LANDING GEAR - LANDING GEAR WARNING HORN REPLACEMENT

The original landing gear warning horn is no longer available. If the landing gear warning horn needs to be replaced, a new landing gear warning horn is available and will require an additional bracket for installation.

MEB-32-03
Page 1 of 31

Figure 1. Before Modification (Sheet 1)

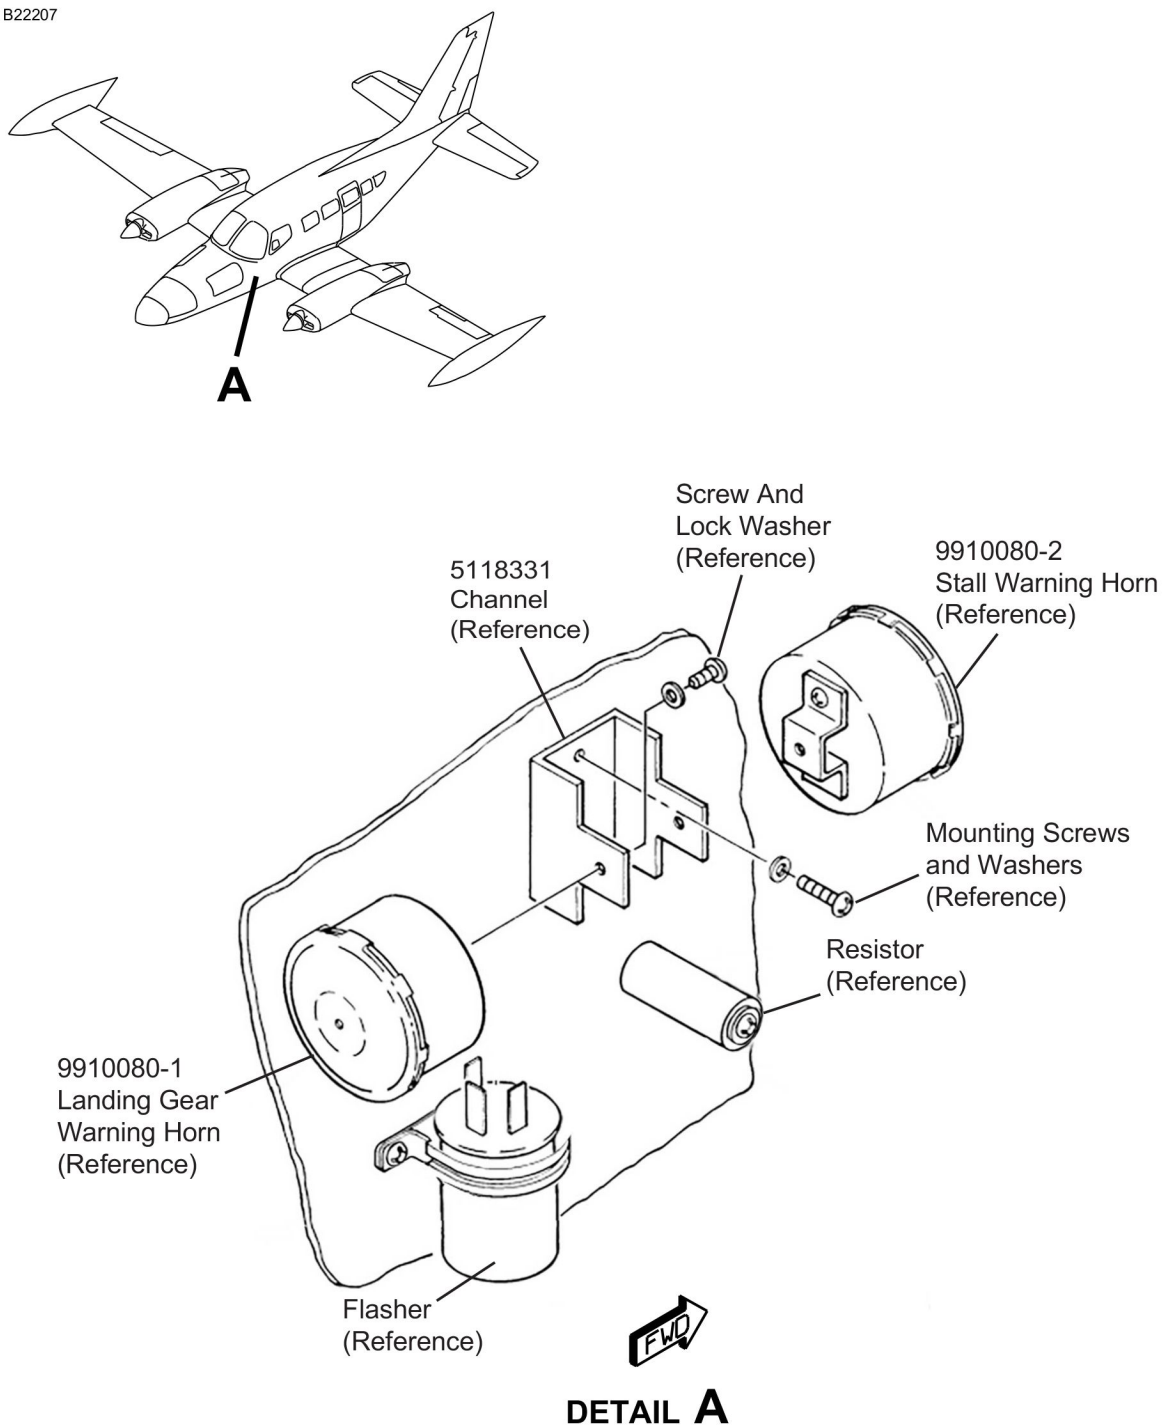
3. (Refer to Figure 1, Sheet 1.) Remove the 9910080-1 Landing Gear Warning Horn as follows:
 - A. Remove and discard the screw and lock washer from the 9910080-1 Landing Gear Warning Horn.
 - B. Disconnect and label the electrical wiring from the 9910080-1 Landing Gear Warning Horn.
 - C. Discard all electrical hardware from the 9910080-1 Landing Gear Warning Horn.
 - D. Discard the 9910080-1 Landing Gear Warning Horn.
 - E. Remove and discard the screw and lock washer from the 9910080-2 Stall Warning Horn.
 - F. Disconnect and label the electrical wiring from the 9910080-2 Stall Warning Horn.
 - G. Discard all electrical hardware from the 9910080-2 Stall Warning Horn.
 - H. Discard the 9910080-2 Stall Warning Horn.
 - I. Remove and keep the two mounting screws from the 5118331 Channel.

Figure 2. Group A Configuration 1 (Sheet 1)

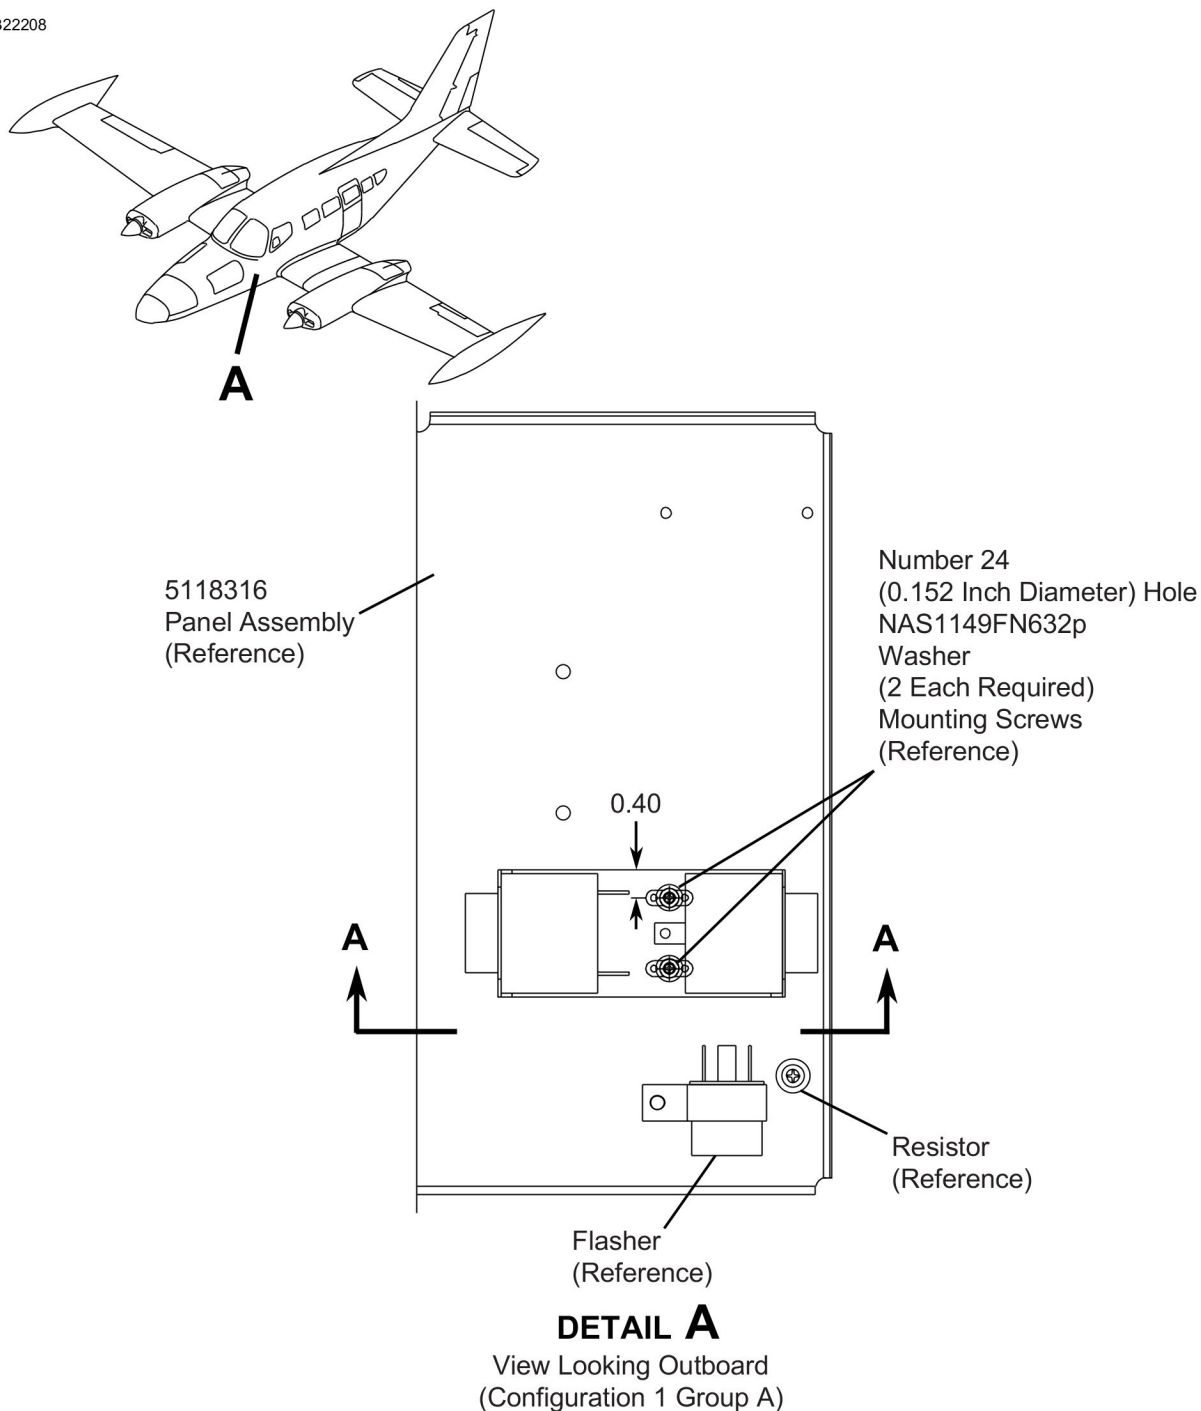
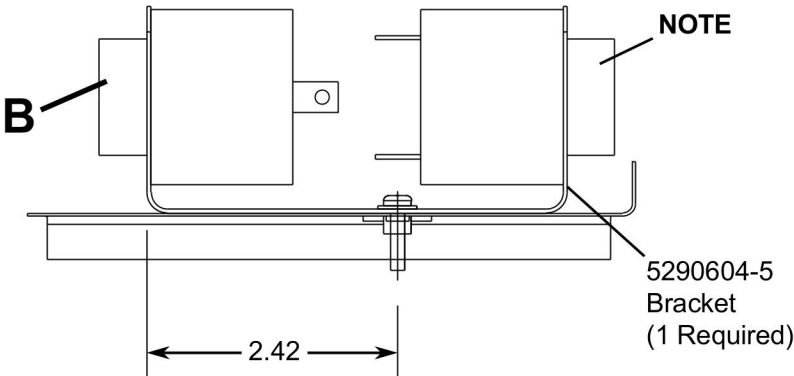
4. (Refer to Figure 2, Sheet 1 and 2.) Install the 9910080-5 Landing Gear Warning Horn as follows:
 - A. Match drill the two Number 24 (0.152 inch diameter) holes of the 5118316 Panel Assembly to the 5290604-5 Bracket.
 - (1) Deburr the drilled holes from the 5290604-5 Bracket.
 - (2) Apply Color Chemical Film Treatment to all bare metal.
 - B. Install the 5290604-5 Bracket with the two kept mounting screws and the two NAS1149FN632P Washers into the 5118316 Panel Assembly.
 - C. Install the 9910080-5 Landing Gear Warning Horn into the 5290604-5 Bracket.
 - D. Install the knurled nut onto the 9910080-5 Landing Gear Warning Horn.

NOTE: The plastic knurled nut must be installed with the three indents toward the bracket and horn assembly. On the internal circumference, the smooth side without threads is installed first, towards the bracket and horn. This technique of installation will make sure the nut fully seats against the bracket and not bottom-out on the threads. If not installed correctly the knurled nut will bottom-out on the threads and the horn assembly will not be fully tightened in the bracket.

Figure 3. Group B Configuration 1 (Sheet 1)

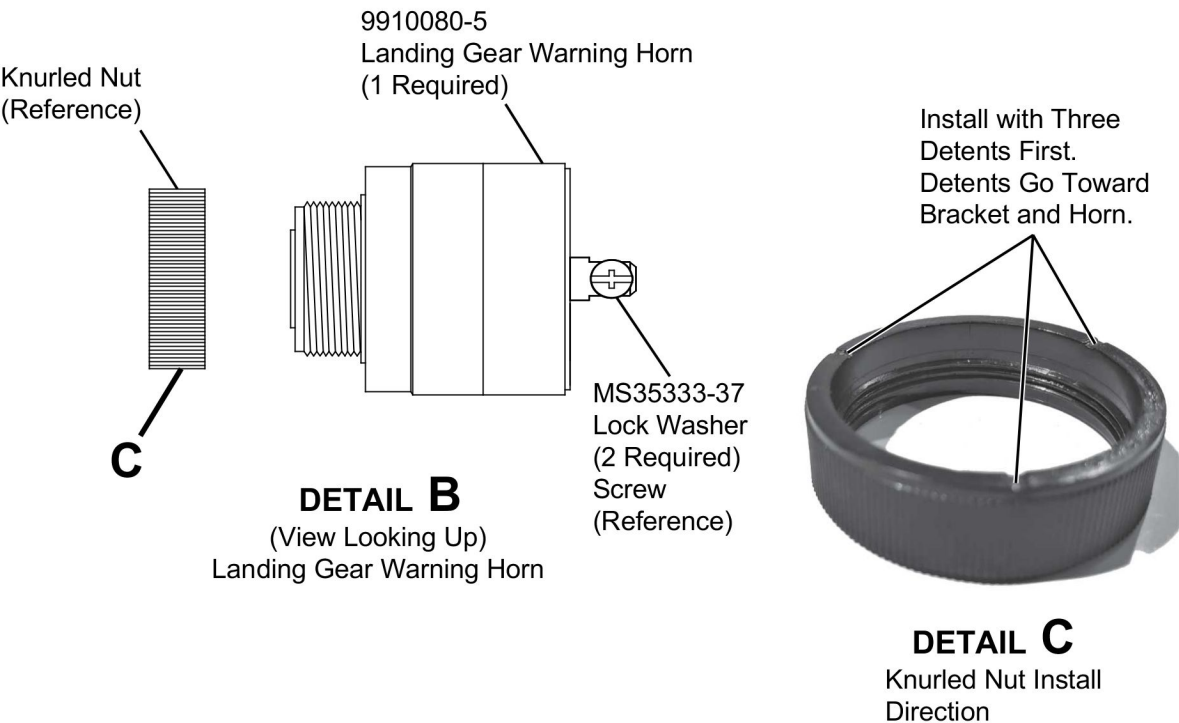
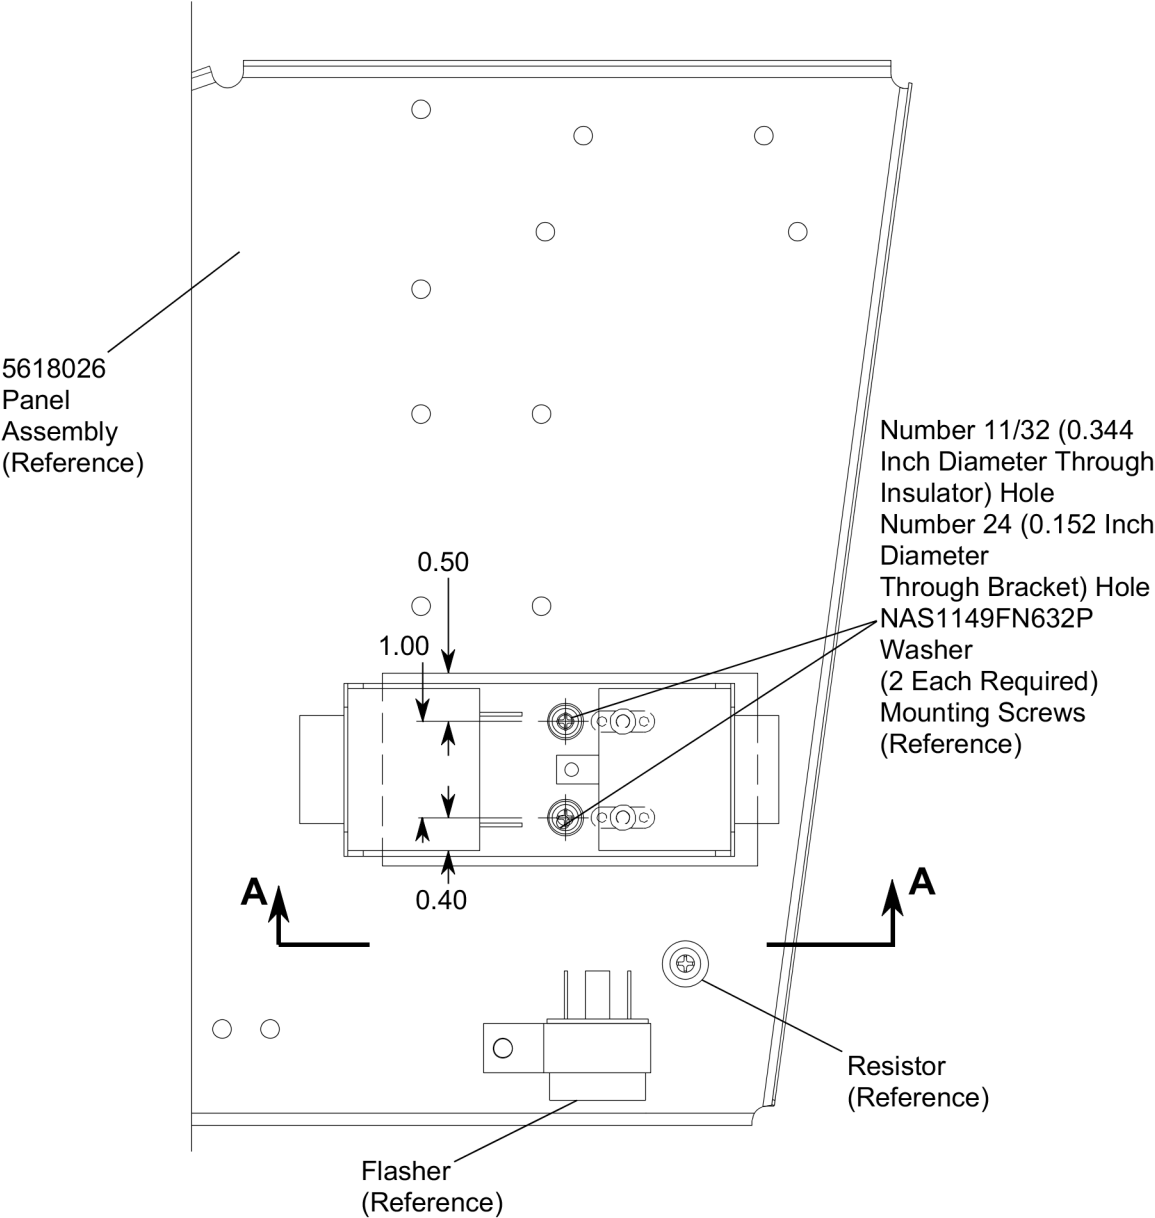
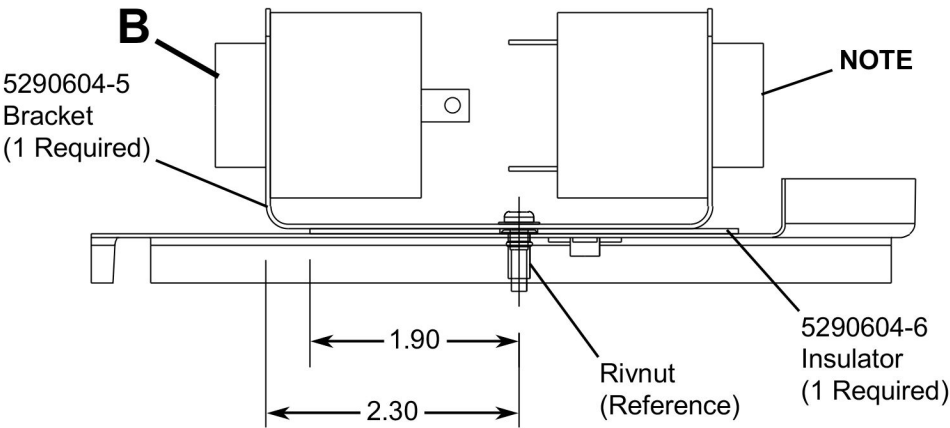
- 9. (Refer to Figure 3, Sheet 1 and 2.) Install the 9910080-5 Landing Gear Warning Horn as follows:

- A. Match drill the two new holes of the 5618026 Panel Assembly to a Number 11/32 (0.344 inch diameter) holes into the 5290604-6 Insulator.
 - (1) Debur the drilled holes from the 5290604-6 Insulator.
- B. Match drill the two new holes of the 5618026 Panel Assembly to a Number 24 (0.152 inch diameter) holes into the 5290604-5 Bracket.
 - (1) Debur the drilled holes from the 5290604-5 Bracket.
 - (2) Apply Color Chemical Film Treatment to all bare metal.
- C. Install the 5290604-5 Bracket and the 5290604-6 Insulator into the rivnuts of the 5618026 Panel Assembly with the two kept mounting screws and the two NAS1149FN632P Washers.
- D. Install the 9910080-5 Landing Gear Warning Horn into the 5290604-5 Bracket.

NOTE: The plastic knurled nut must be installed with the three indents toward the bracket and horn assembly. On the internal circumference, the smooth side without threads is installed first, towards the bracket and horn. This technique of installation will make sure the nut fully seats against the bracket and not bottom-out on the threads. If not installed correctly the knurled nut will bottom-out on the threads and the horn assembly will not be fully tightened in the bracket.

Figure 3. Group B Configuration 1 (Sheet 3)

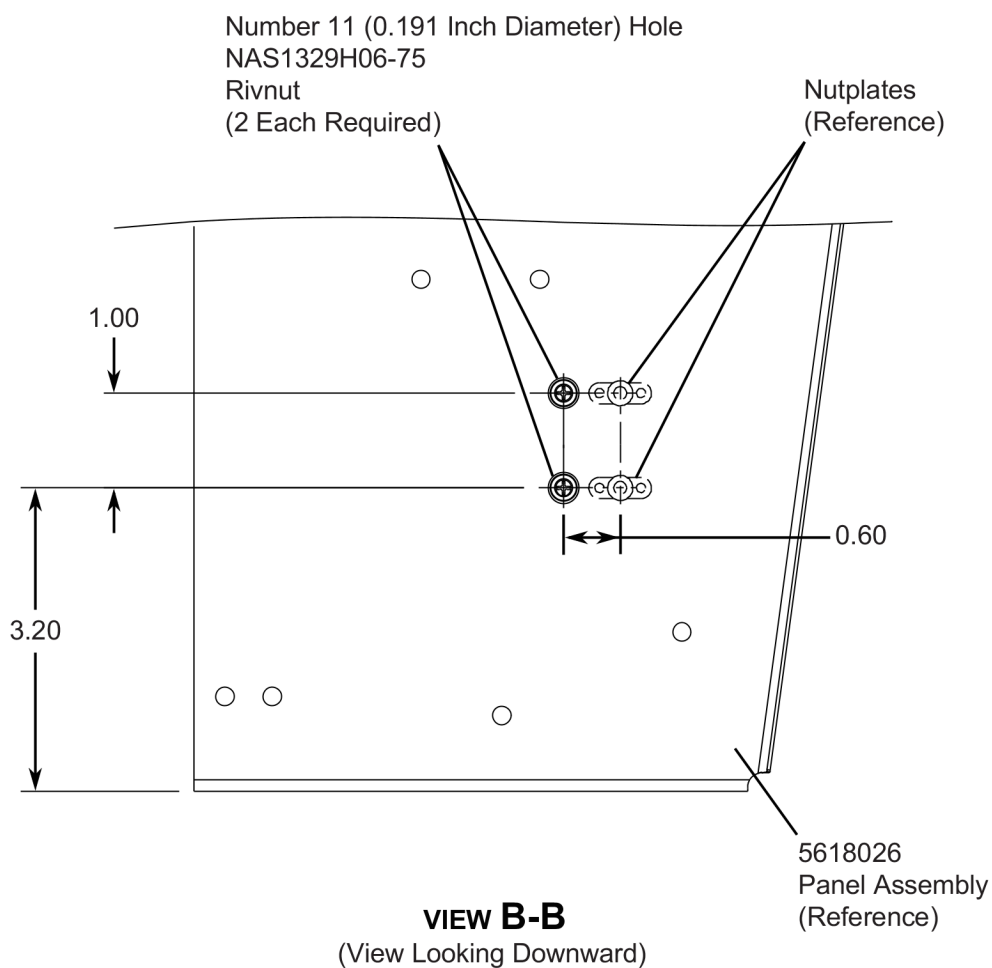
- 8. (Refer to Figure 3, Sheet 3.) Locate and drill the two holes into the 5618026 Panel Assembly as follows:

- A. Locate and drill the two Number 11 (0.191 inch diameter) holes into the 5618026 Panel Assembly.
 - (1) Debur the drilled holes from the 5618026 Panel Assembly.
 - (2) Apply Color Chemical Film Treatment to all bare metal.

Figure 4. Group A Configuration 2 (Sheet 1)

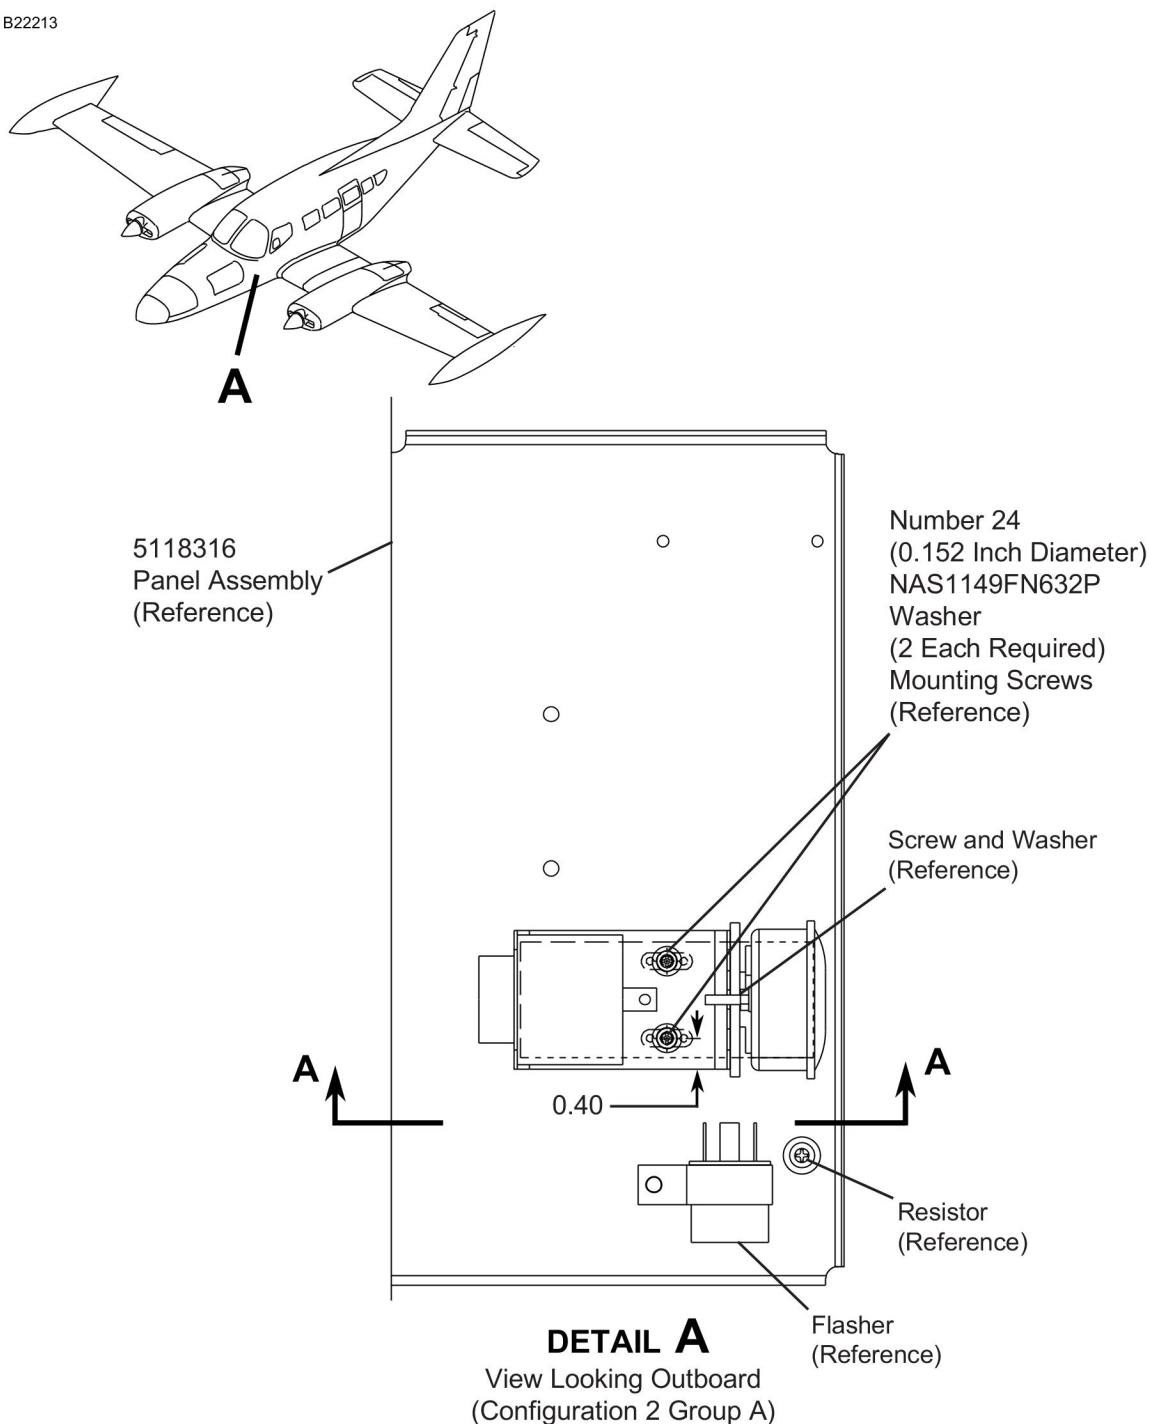
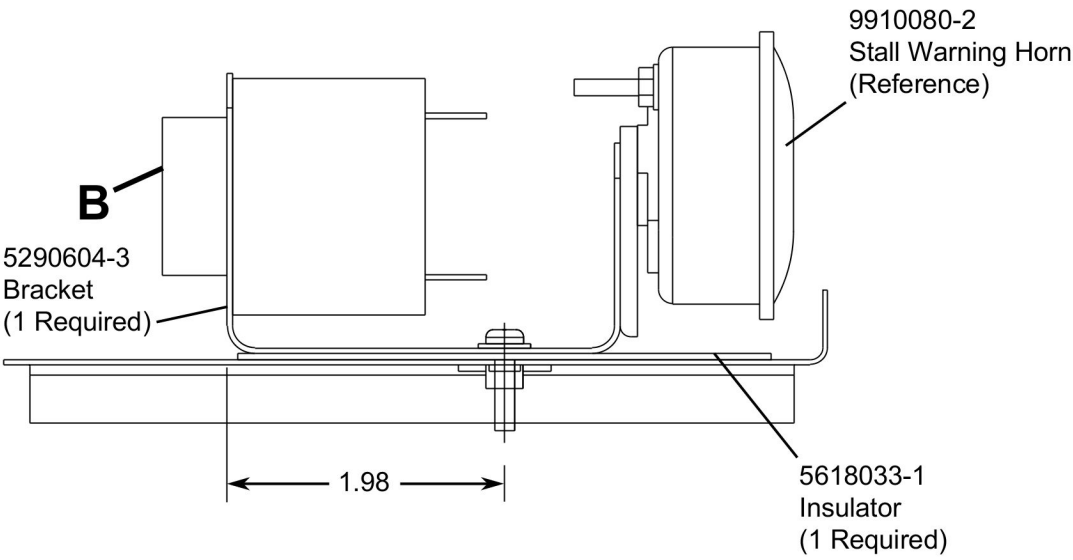
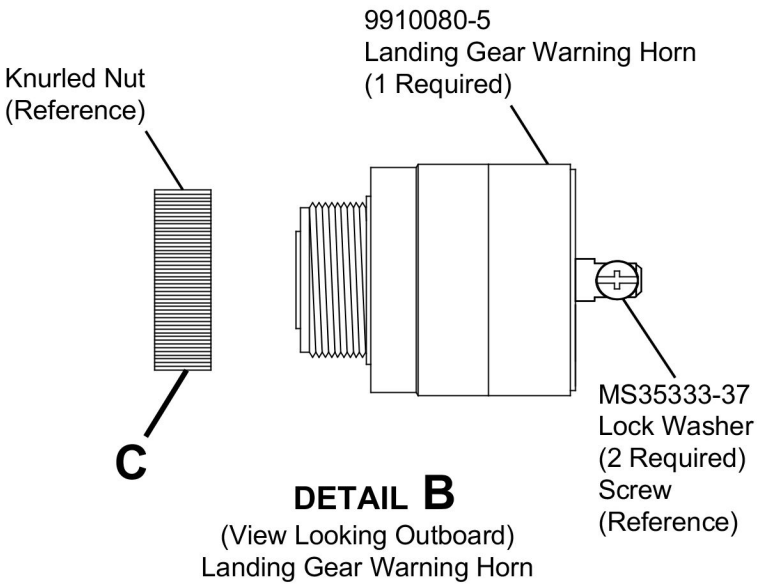
14. (Refer to Figure 4, Sheet 1 and 2.) Install the 9910080-5 Landing Gear Warning Horn as follows:
- A. Match drill the two Number 24 (0.152 inch diameter) holes of the 5118316 Panel Assembly into the 5290604-3 Bracket.
 - (1) Debur the drilled holes from the 5290604-3 Bracket.
 - (2) Apply Color Chemical Film Treatment to all bare metal.
 - B. Install the 5290604-3 Bracket and the 5618033-1 Insulator with the two kept mounting screws and the two NAS1149FN632P Washers into the 5118316 Panel Assembly.
 - C. Install the 9910080-5 Landing Gear Warning Horn into the 5290604-3 Bracket.
 - D. Install the knurled nut onto the 9910080-5 Landing Gear Warning Horn.

NOTE: The plastic knurled nut must be installed with the three indents toward the bracket and horn assembly. On the internal circumference, the smooth side without threads is installed first, towards the bracket and horn. This technique of installation will make sure the nut fully seats against the bracket and not bottom-out on the threads. If not installed correctly the knurled nut will bottom-out on the threads and the horn assembly will not be fully tightened in the bracket.
 - E. Install the labeled electrical wiring, screws, and the two MS35333-37 Lock Washers into the 9910080-5 Landing Gear Warning Horn.
